DUKE POWER COMPANY  
OCONEE NUCLEAR STATION  
ATTACHMENT 1a  
IMPROVED TECHNICAL SPECIFICATIONS

This proposed amendment revises the pressure-temperature limits of Improved Technical Specification (ITS) 3.4.1 and Current Technical Specification (CTS) 3.1.2 for Oconee Units 1, 2, and 3. The proposed amendment will revise the heatup, cooldown, and inservice test limitations for the reactor coolant system of each unit. For Units 1, 2, and 3, the current pressure-temperature limits are established to 21, 19, and 21 effective full power years (EFPY), respectively. The service period for the new pressure temperature limits will be to a maximum of 26 EFPY for Units 1, 2 and 3.

Figure 3.4.3-4 (page 1 of 1)  
RCS Normal Operational Heatup Limitations  
Applicable for the First 19 EFY - Oconee Nuclear Station Unit 2

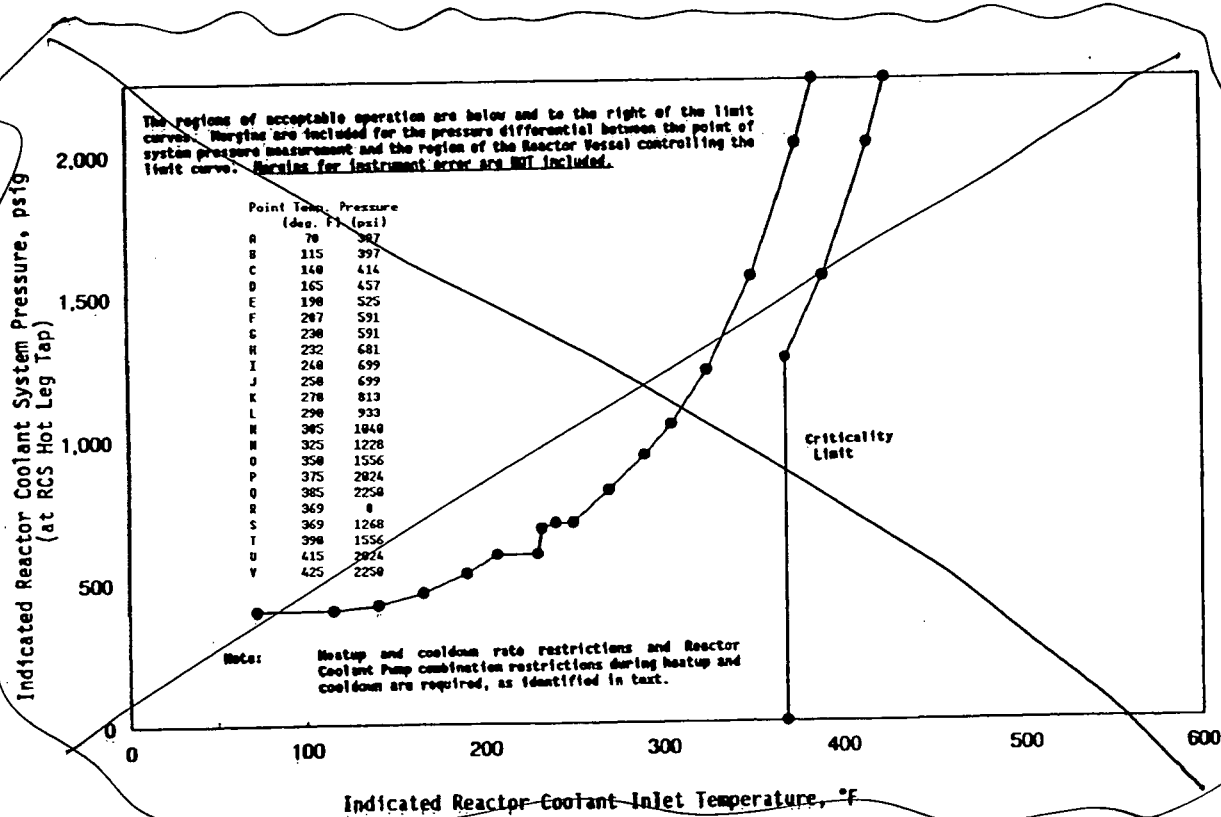
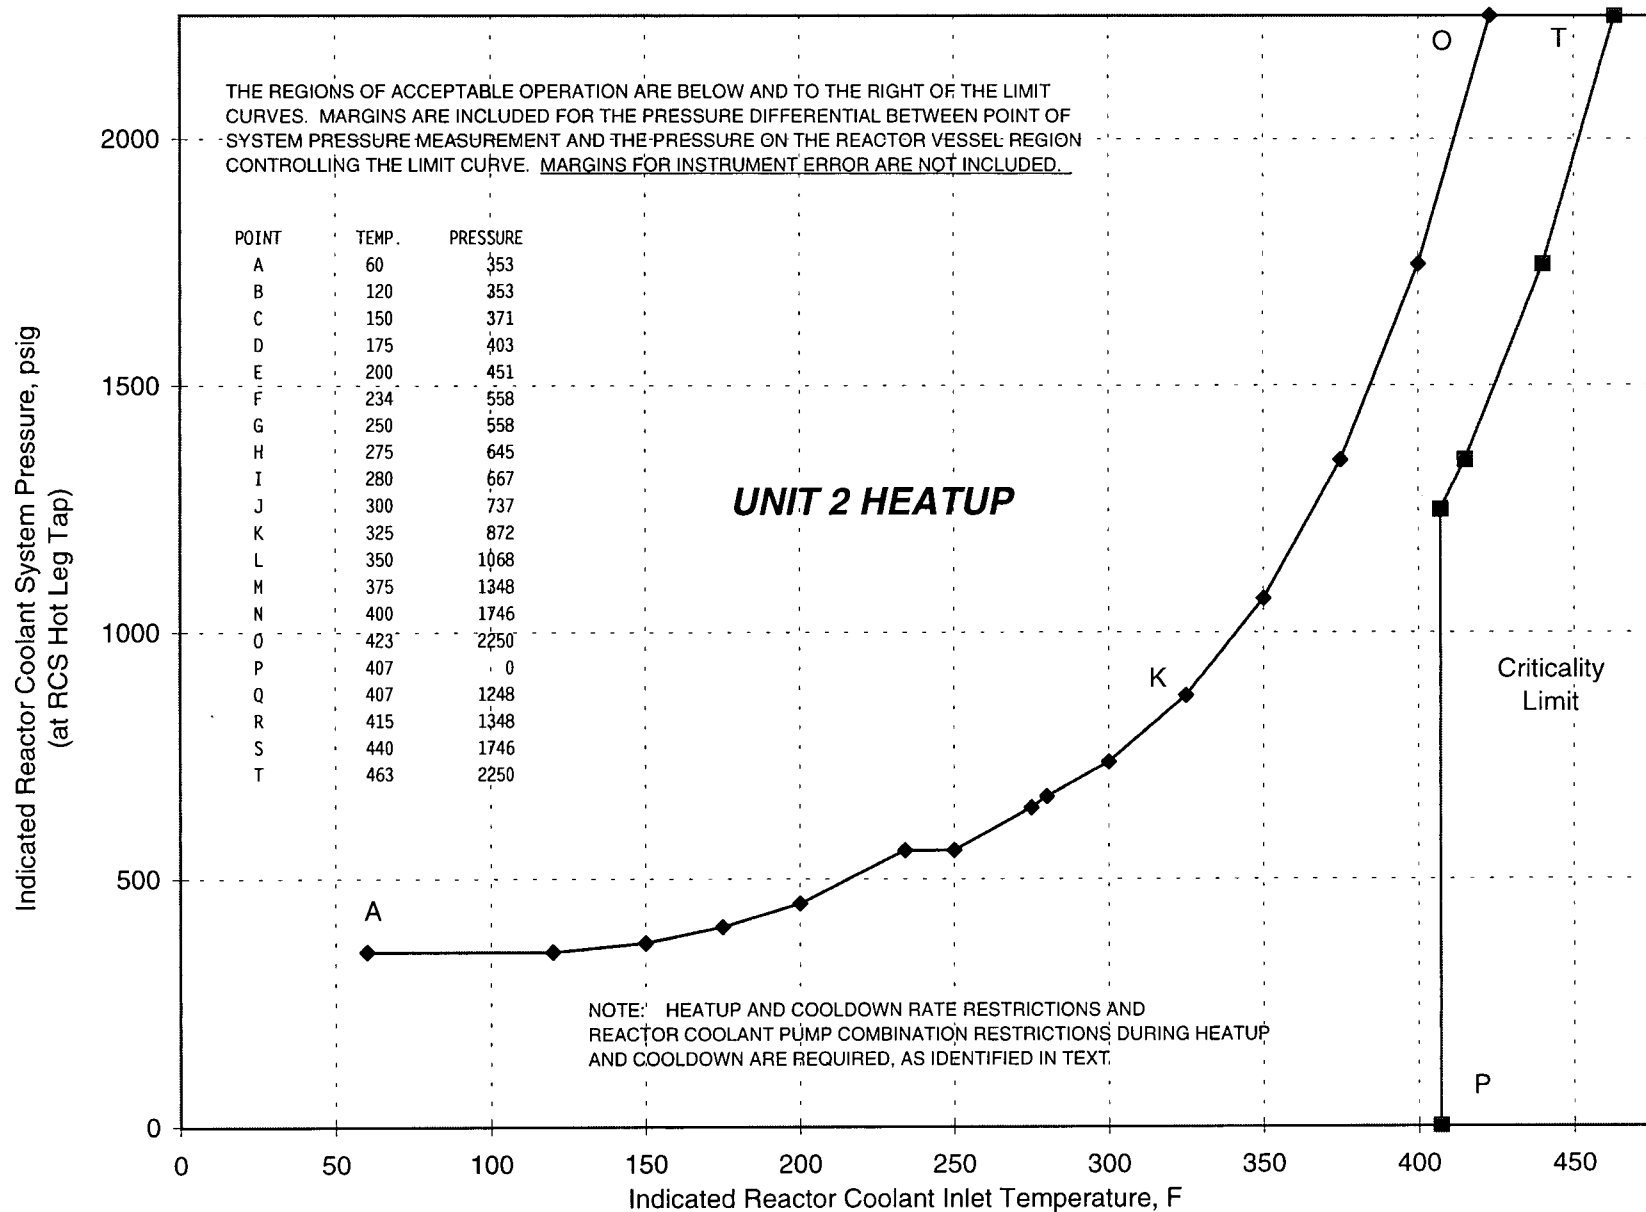
INSERT REVISED FIGURE

INSERT FOR FIGURE 3.4.3-4

Figure 3.4.3-5 (page 1 of 1)  
RCS Normal Operational Cooldown Limitations  
Applicable for the First 19 EFY - Oconee Nuclear Station Unit 2

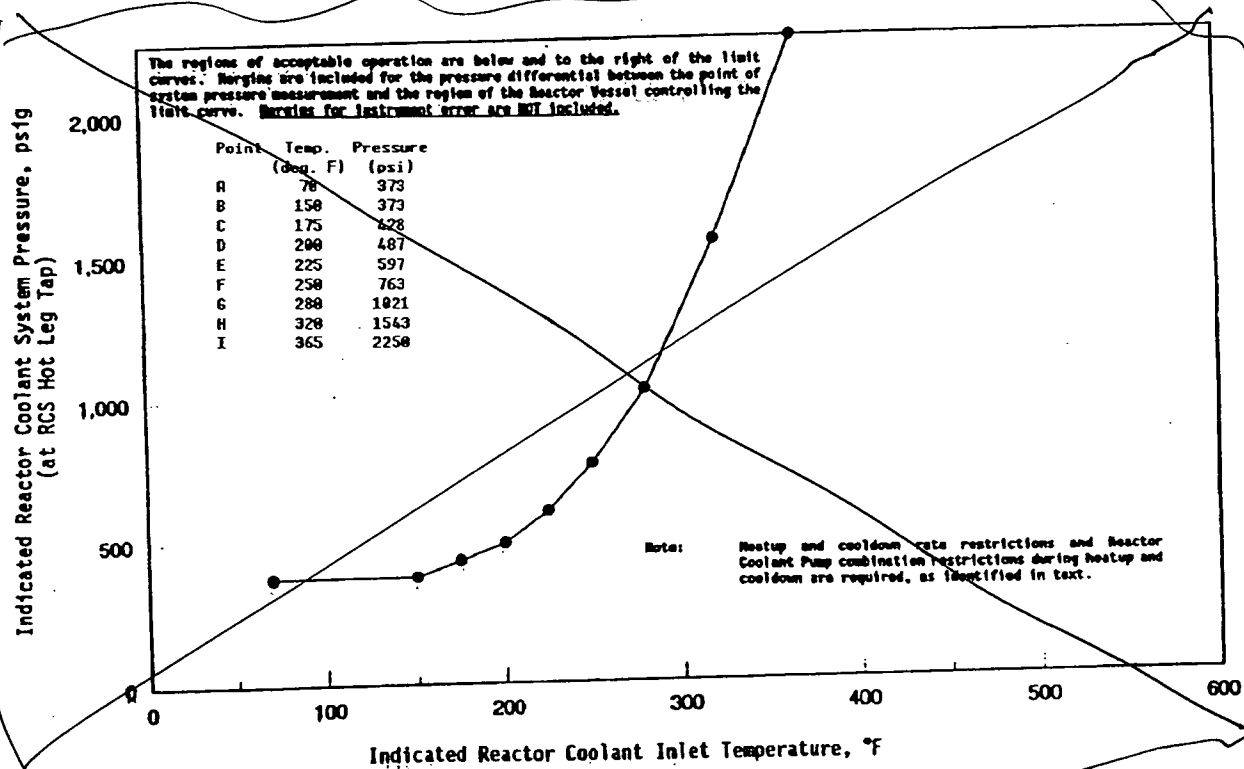
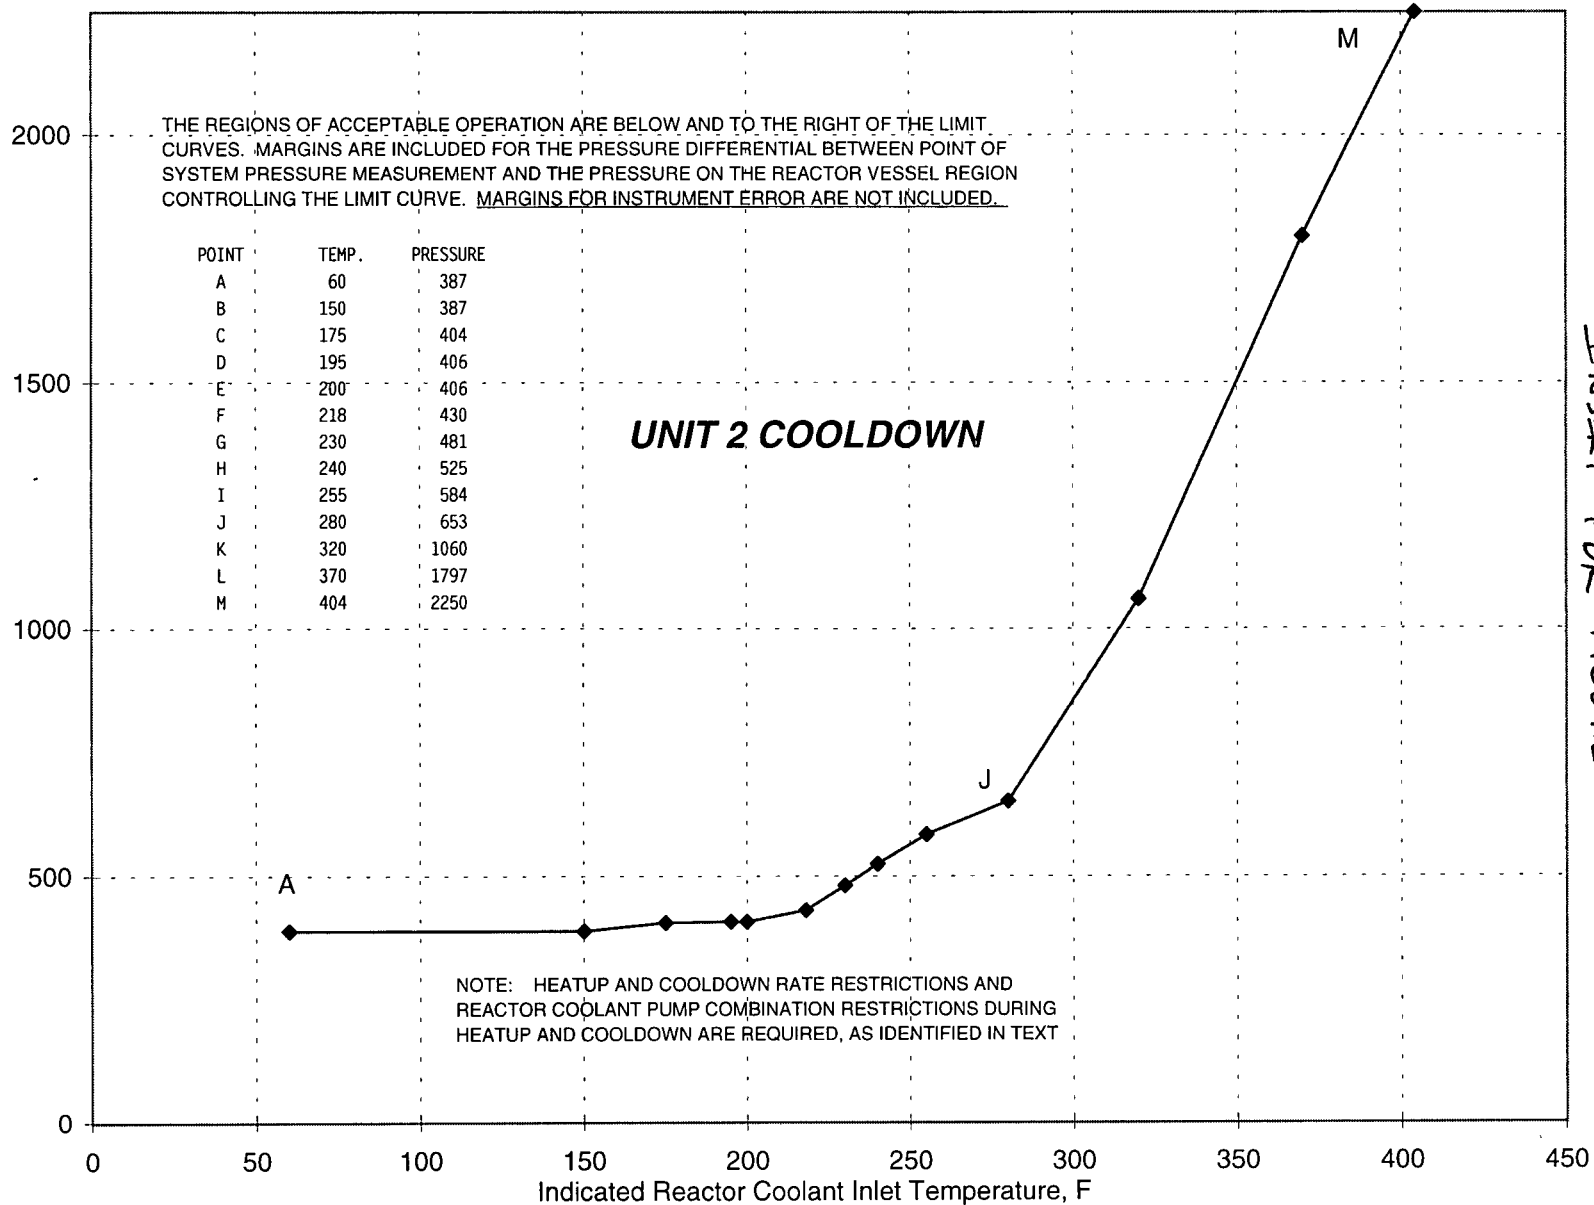
# INSERT REVISED FIGURE

INSERT FDR FIGURE 3.4.3-5

Figure 3.4.3-6 (page 1 of 1)  
RCS Leak and Hydrostatic Test Heatup and Cooldown Limitations  
Applicable for the First 19 EFY - Oconee Nuclear Station Unit 2

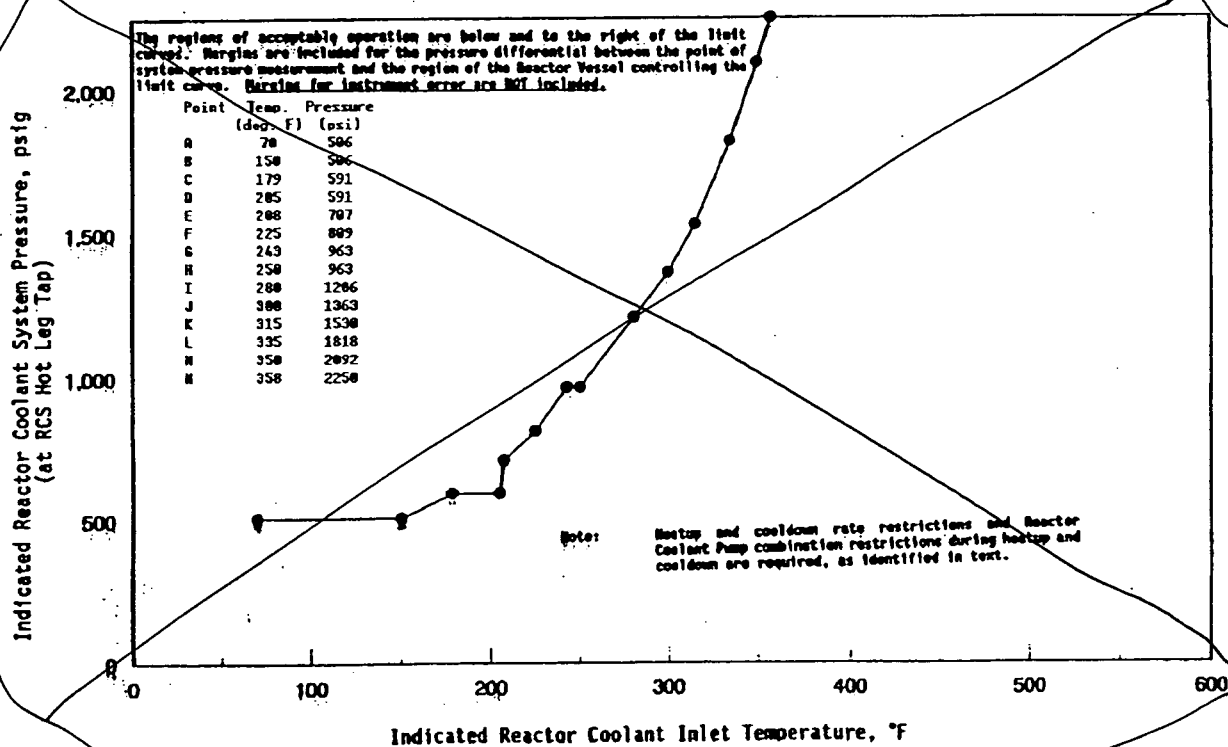
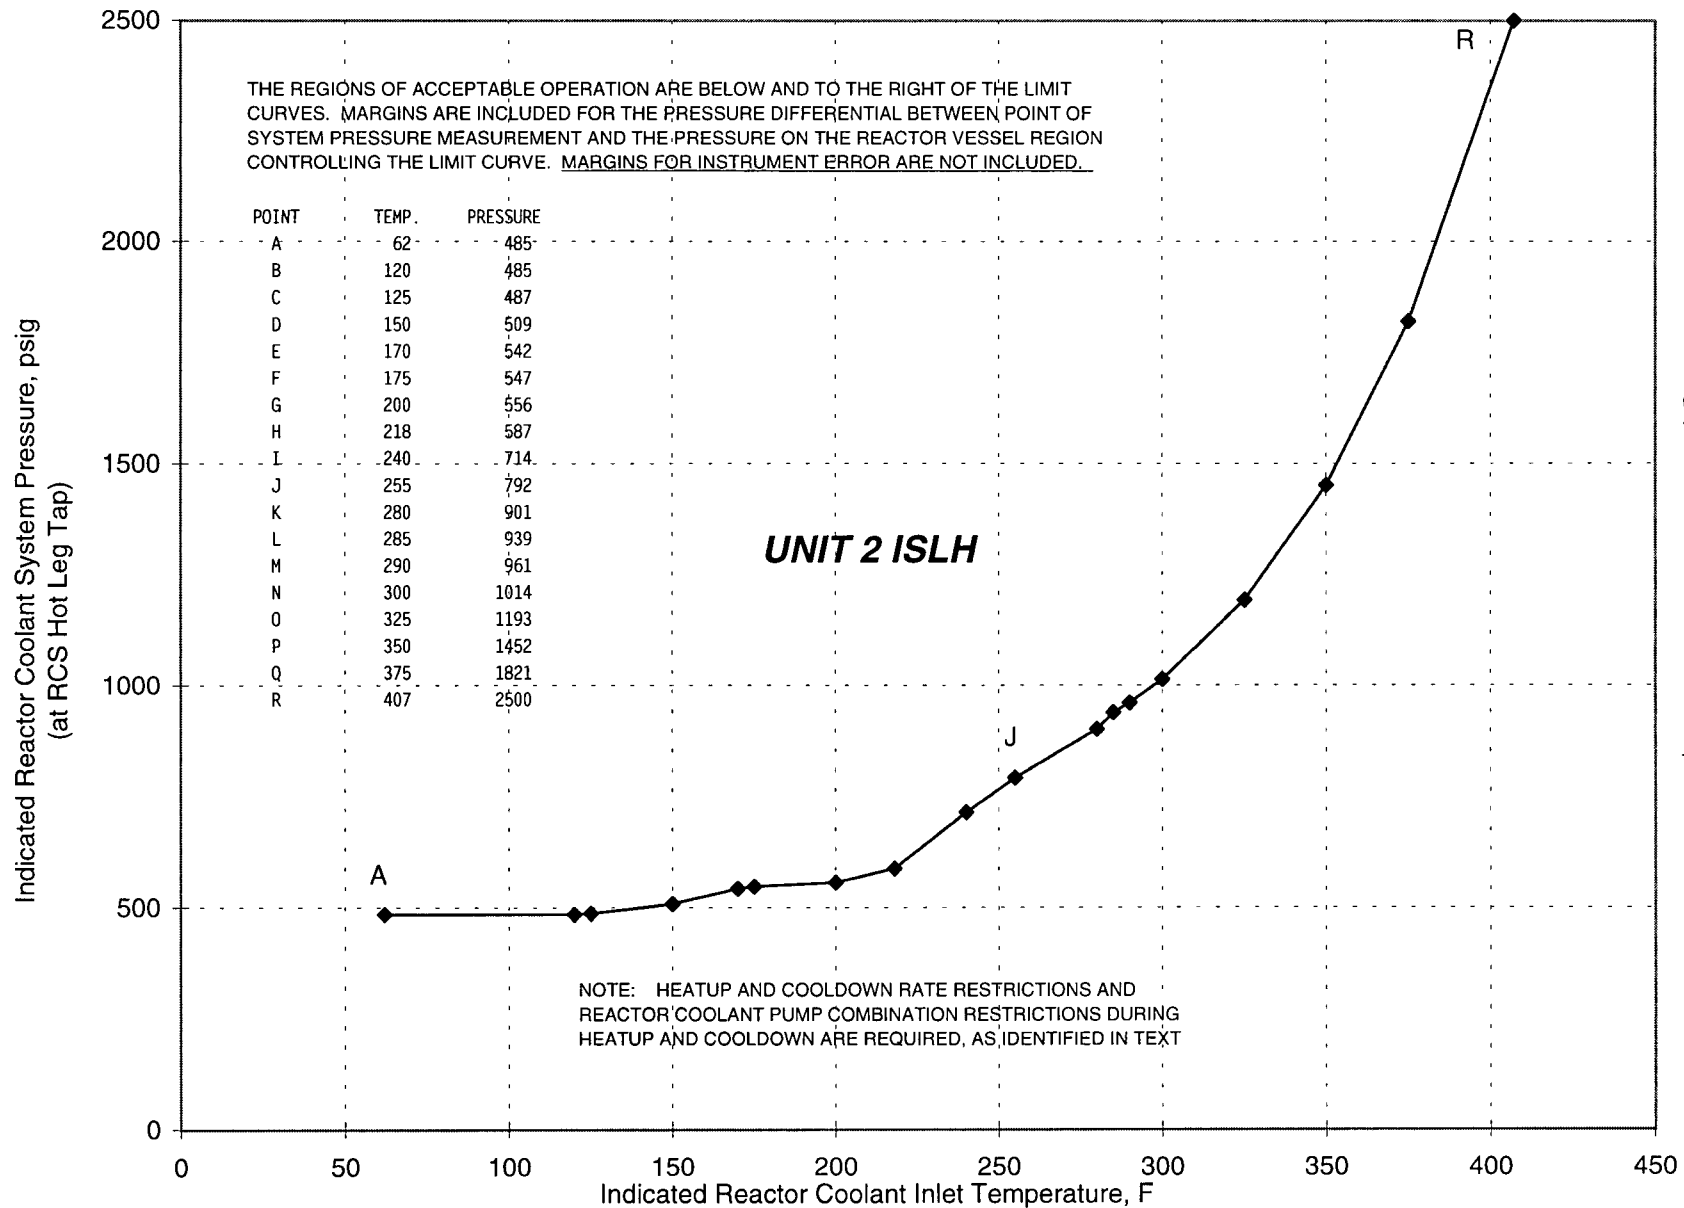
INSERT REVISED FIGURE

INSERT FOR FIGURE 3.4.3-6
